ADMINISTRATIVE AMENDMENT

PROJECT NUMBER: 1004606
APPLICATION NUMBER: 14DRB-70202

DURANGO

Site Plan for Subdivision

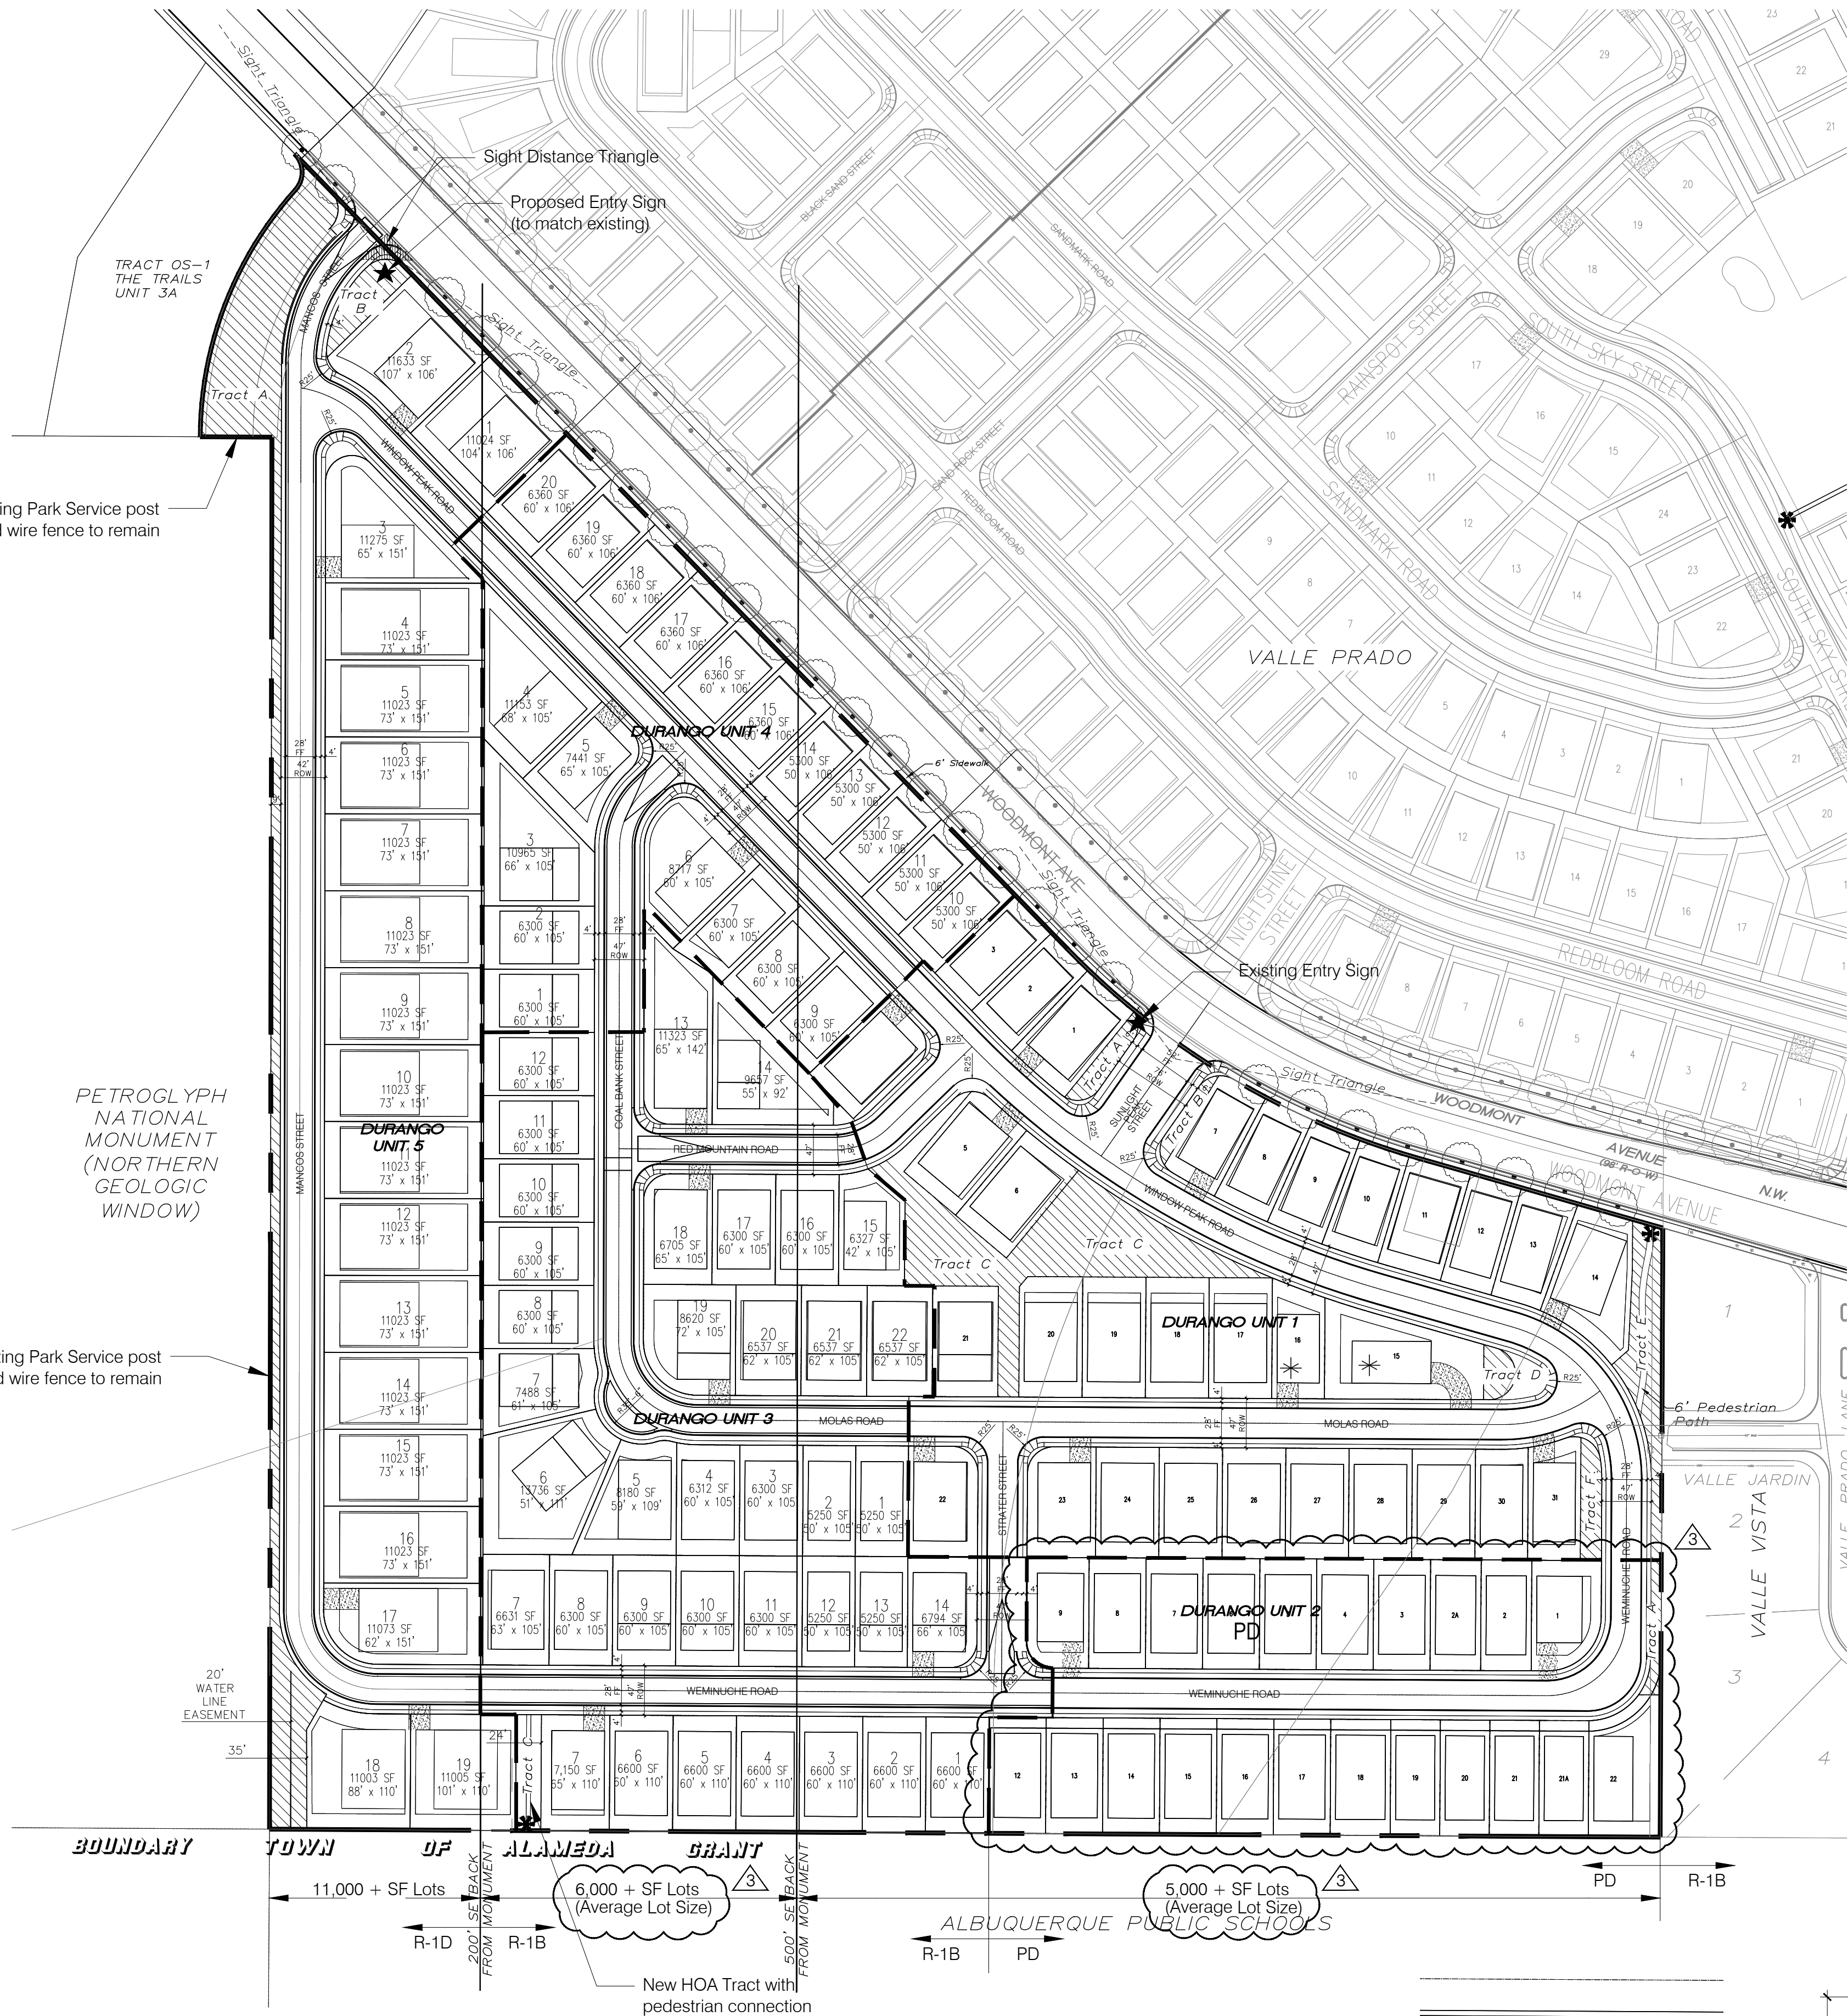
- ADMINISTRATIVE AMENDMENT JANUARY 20, 2022:
- MODIFIED LOT SIZES WITHIN UNIT 2. THE MINIMUM LOT SIZE IS CONSISTENT WITH R1-B STANDARDS.
 - ELIMINATED PEDESTRIAN CONNECTION AT SOUTHEAST CORNER. NEW PEDESTRIAN CONNECTION ADDED TO THE WEST, TRACT C, WITH PREVIOUS AMENDMENT.
 - AVERAGE LOT SIZE = 5,796 SF
 - REMOVED HOA TRACTS A & B (NO HOA)
 - INCREASED NUMBER OF LOTS WITHIN UNIT 2 FROM 20 TO 22
